Grove Lodge, Admiral's Walk

Review of First Steps BIA Response

MAM7409-RT003-R01-00

September 2015

Figure 7.1: Cross-section illustrating groundwater levels.

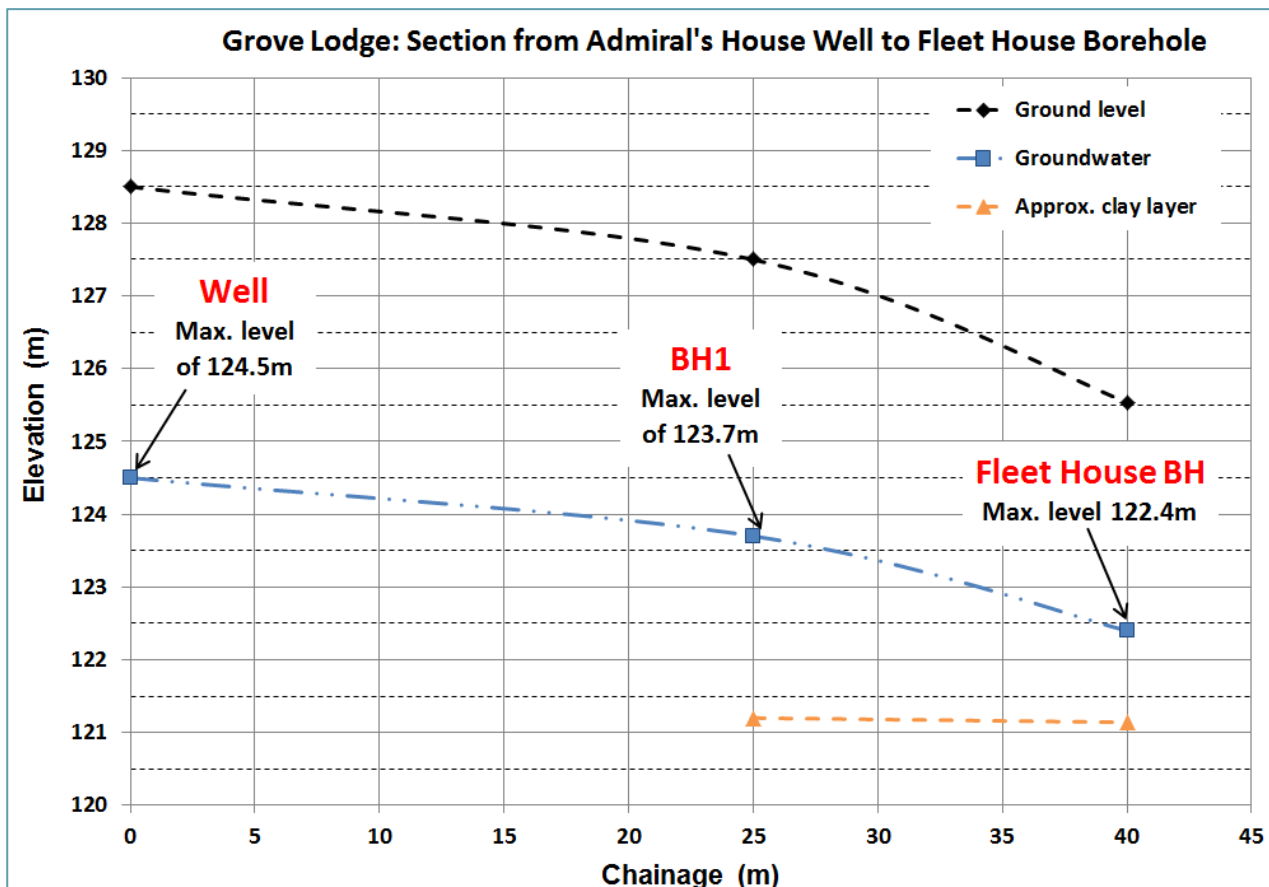
It is noted by Dr de Freitas that using the various figures "*water levels range over 6.09m*".

In addition, even if one ignores any uncertainties, the statement is misleading. The well provides clear evidence that there are separate groundwater levels at that location and that these are several metres apart (vertically). Water at a higher (perched) level – enters through the sides of the well and drains down the inside. The well acts as a drain, linking the upper water level to the deeper one. To take the difference between the two separate water levels and to imply that water could be anywhere within the range is misleading.

It must also be noted that there is an incomplete acknowledgement of the effect of the hydraulic gradient that occurs in the area. The available data for the swimming pool and well, for BH1 and a borehole at Fleet

House on the edge of Admiral's Walk (water level at approximately 122.4m) indicates a significant hydraulic gradient in that area. The perched groundwater levels at the basement site will be significantly less than the perched water levels at the well and at the swimming pool. For Dr de Freitas to quote levels at those locations and simply to compare them to the basement level is quite inappropriate. This is illustrated on Figure 7.1 – a long-section from the well, through the site of BH1, to a borehole drilled at the edge of Admiral's Walk at Fleet House (2012). Whilst it is accepted that the groundwater level data illustrated is for different days, we have included the highest levels available for each site.

Our approach of recognising changes in groundwater level across the area and to use actual groundwater levels from the basement site is considered to be the most robust approach.
